# Clonburris T1

## Amendments Submission

For Proposed Residential Development  
Clonburris T1, Co. Dublin

Compliance Submission in Accordance with  
Planning Condition no. 3 (Reg. Ref: SDZ21A/022)

Amended End of Terrace

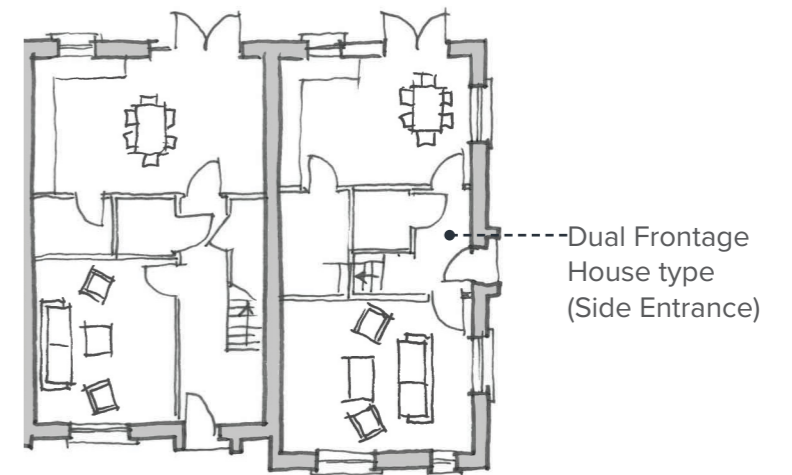
(a) House type 19014 PL 112 Rev A shall be revised to dual frontage. The main frontage shall face the canal

The end house types in the row of units have been revised to address the surrounding streets. The main entrance has been changed to the side so as to create a dual frontage house type. This revision will lend more character and help activate the surrounding road network with footfall and passive surveillance. With the revised layout the end units now benefit from larger living rooms facing out onto the canal. This also aides in providing variety to the linear elevation facing the canal.

Amended Street Elevation

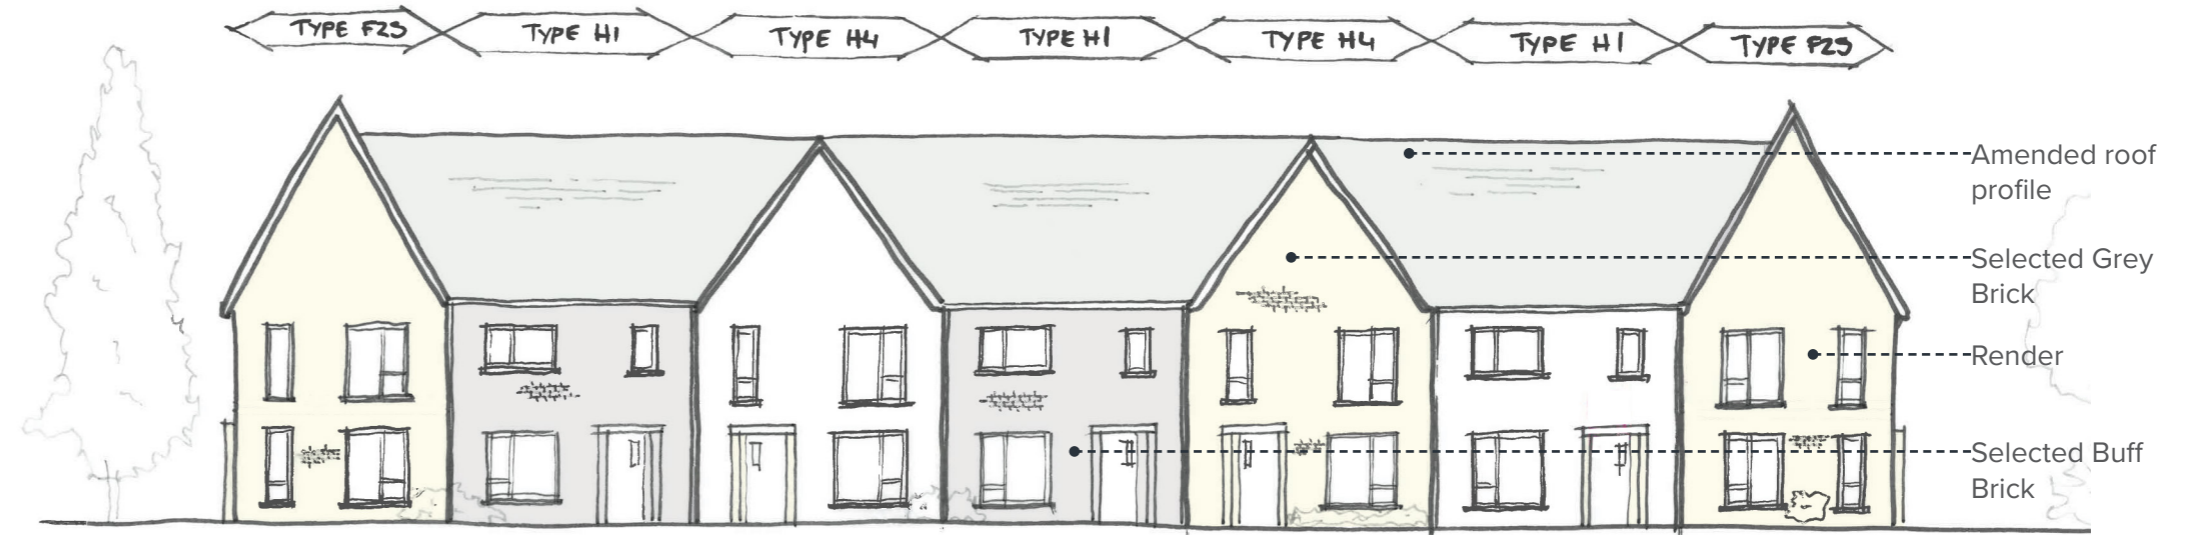
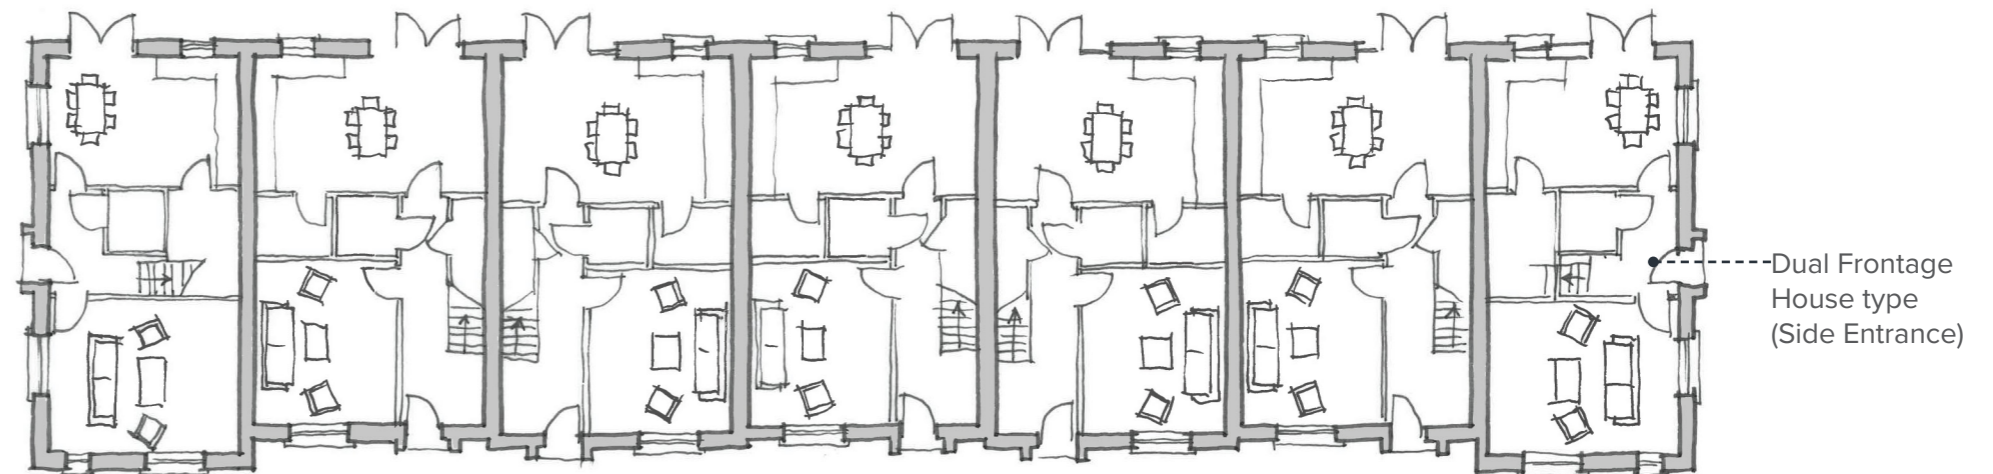
Revised plans that incorporate all of the following amendments-  
 (b) House Types H1, H2 shall be revised. Each plot shall have an individual distinctive design, in accordance with Section 2.4.3 of the Planning Scheme.

Having reviewed some of the vernacular typologies around the area and in conjunction with the strategic Development Zone plan we have amended the subject house types to create a more distinctive urban grain. The material use, ridge pattern and roof profiles of the houses have been revised to create a more varied streetscape combining a more traditional roofscape mixed with a contemporary gable facade.

Topography and Roofscape Diagram / Drawing Ref: CLB-1-00-SW-ZZ-DR-CWO-AR-1000

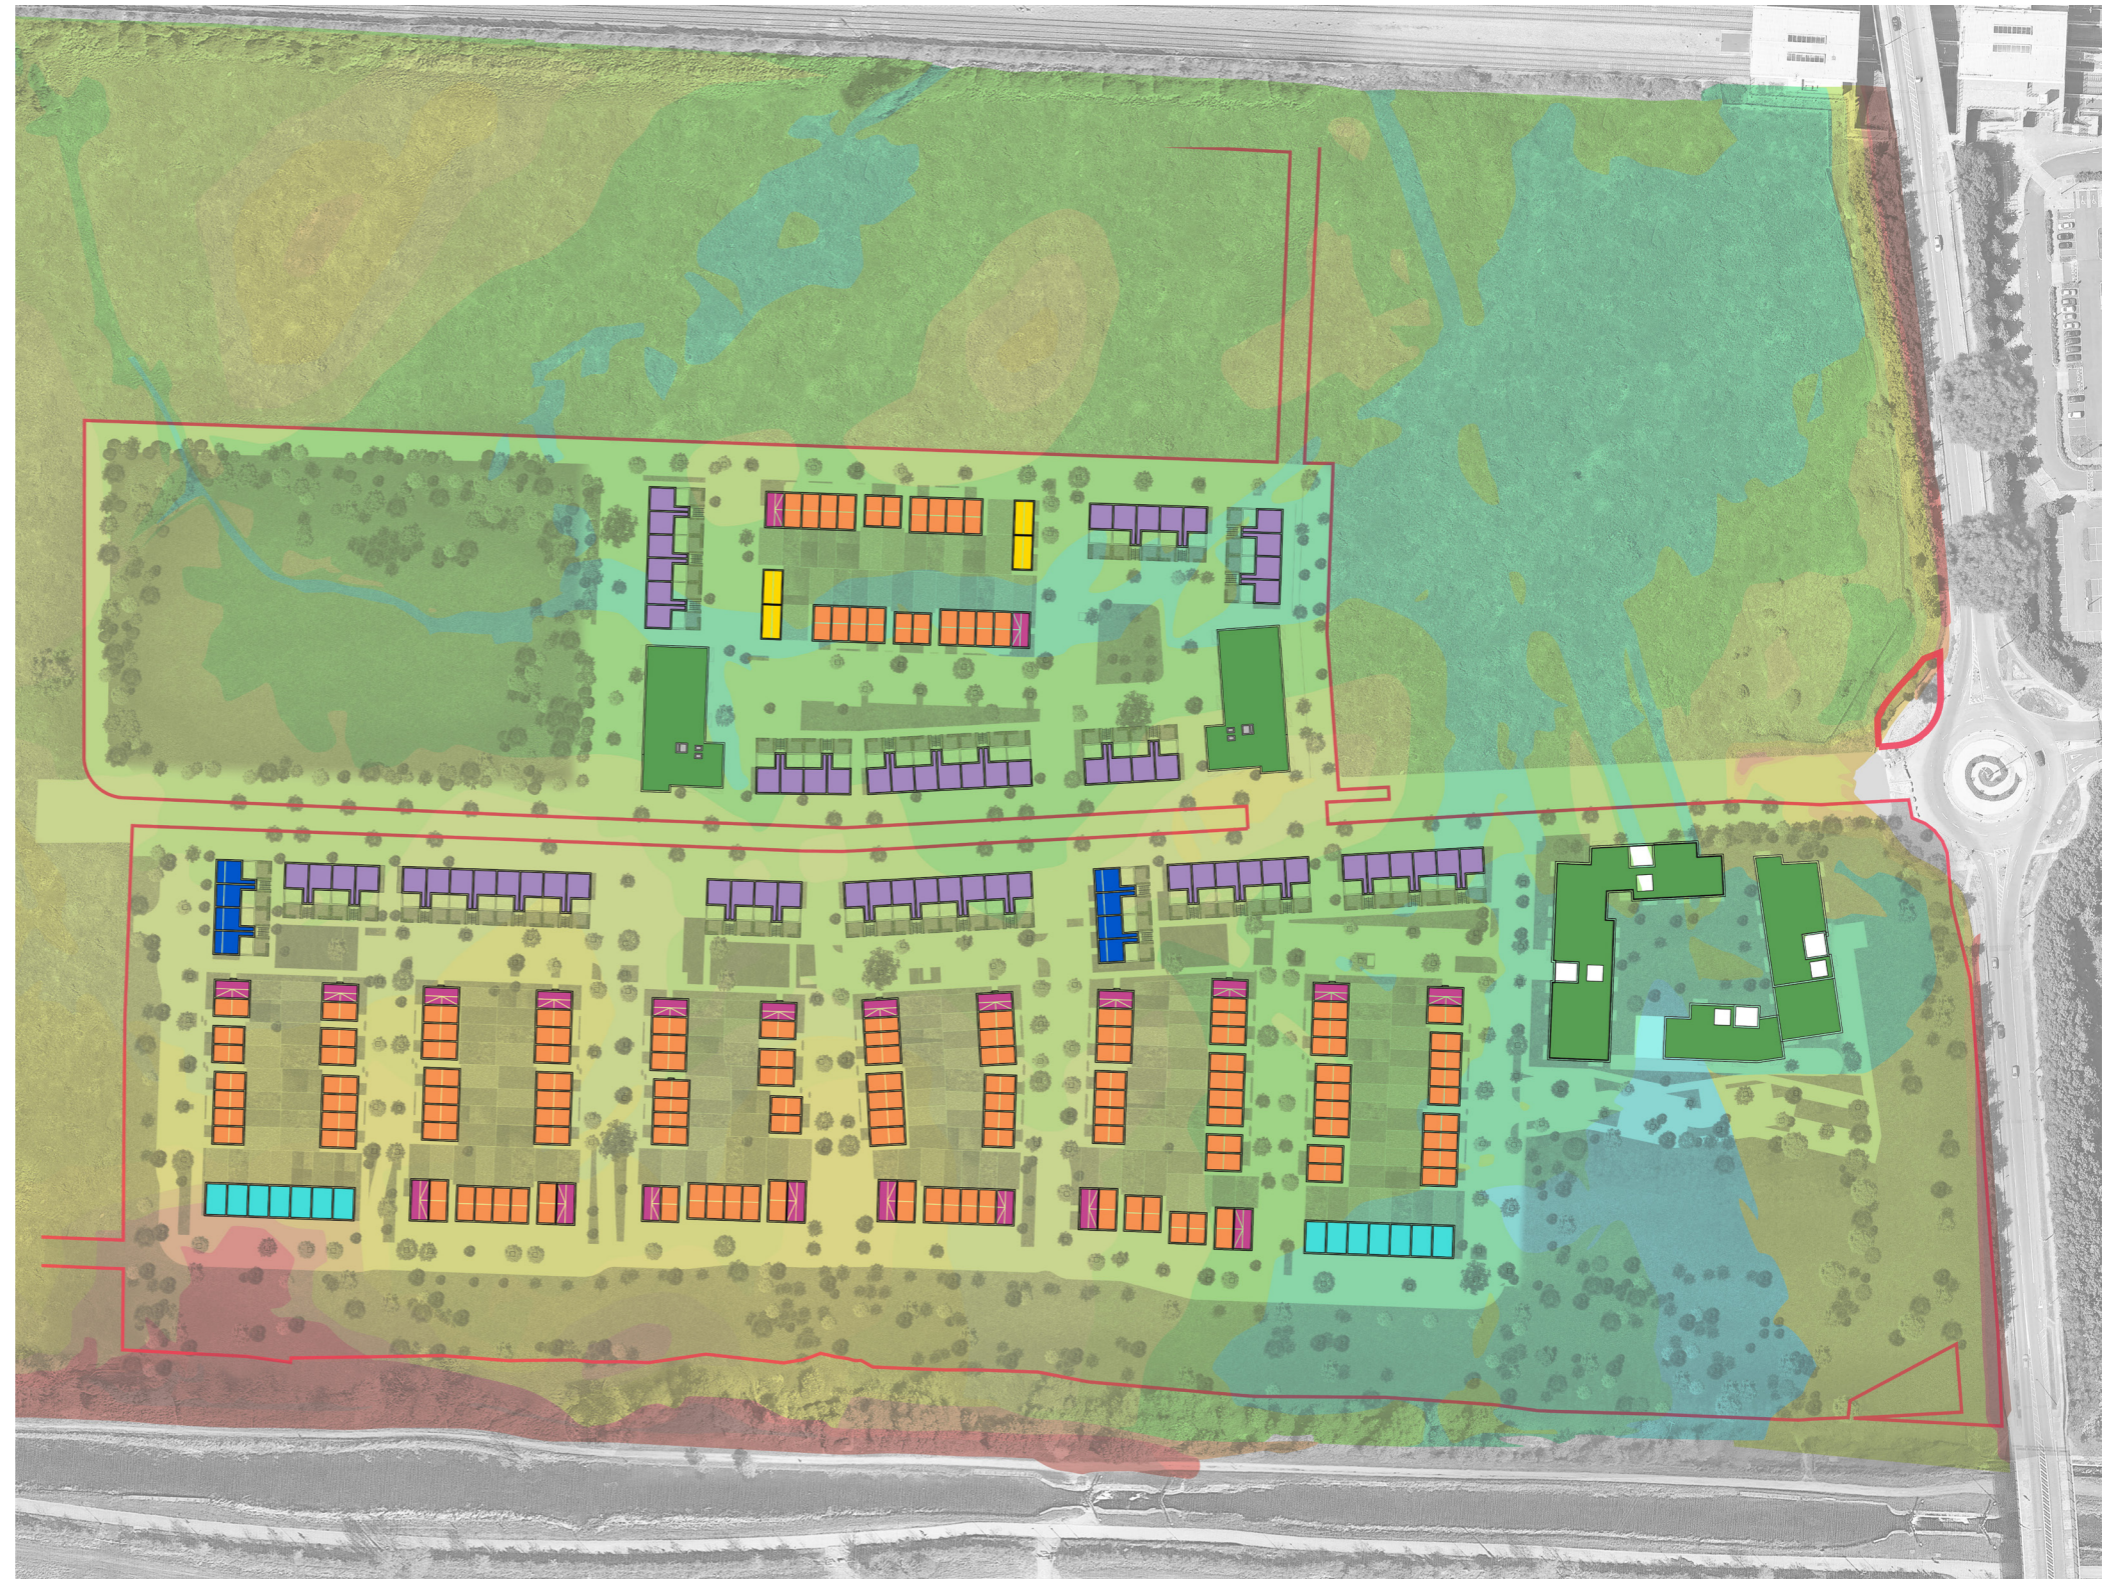
Revised plans that incorporate all of the following amendments-  
 (c) the applicant shall undertake an assessment of topography across the site and shall identify areas where dwelling / duplex height can be varied. Following agreement of these areas with the Planning Authority, revised plans shall be submitted indicating a varied roofscape for the written agreement of the Planning Authority

An assessment of the topography across the site has been undertaken and, where feasible, dwelling and duplex height has been varied. The levels across the site have been developed to ensure compliance with Part M and access to all dwellings.

The adjacent diagram shows the changes in topography across the site with levels varying by 6m. The varied roofscape is further accentuated by the mix of roofscapes employed across the scheme to ensure visual interest.

Typical Duplex Bin Store / Drawing Ref: 1738\_PLC\_P\_00

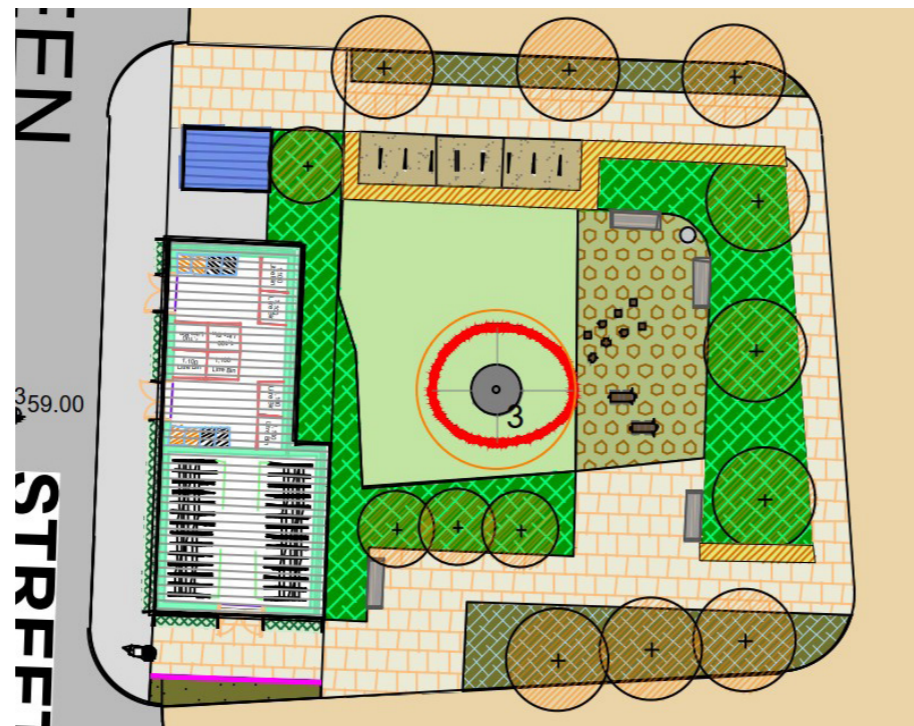
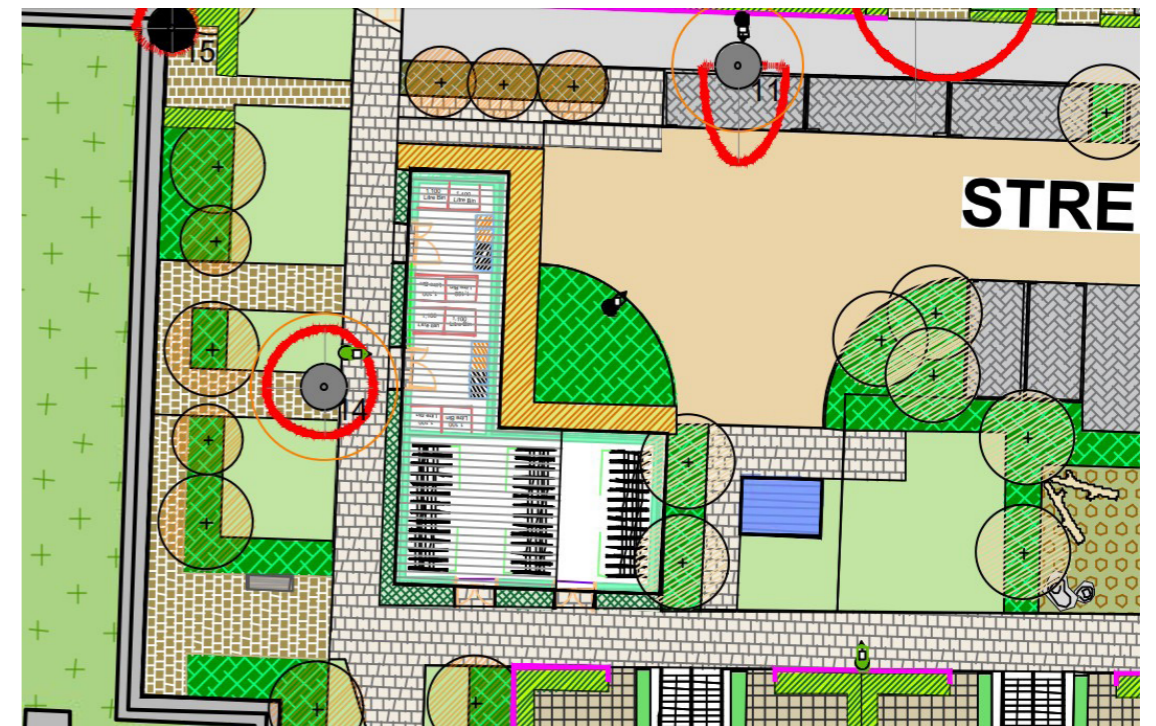
Revised plans that incorporate all of the following amendments-  
 (d) The bin storage areas shall include green roofs / walls, where feasible

As shown in the plans, the bin storage areas have all been treated with additional green walls where feasible. Typically standard public realm planting is used adjacent to the bin storage areas. A trellis system with a hedge has been used where the spaces are narrower to ensure that ample green walls are provided. The landscaping treatment is set out in more detail in the Landscape drawings prepared by Murray & Associates as submitted for compliance with Condition 12.
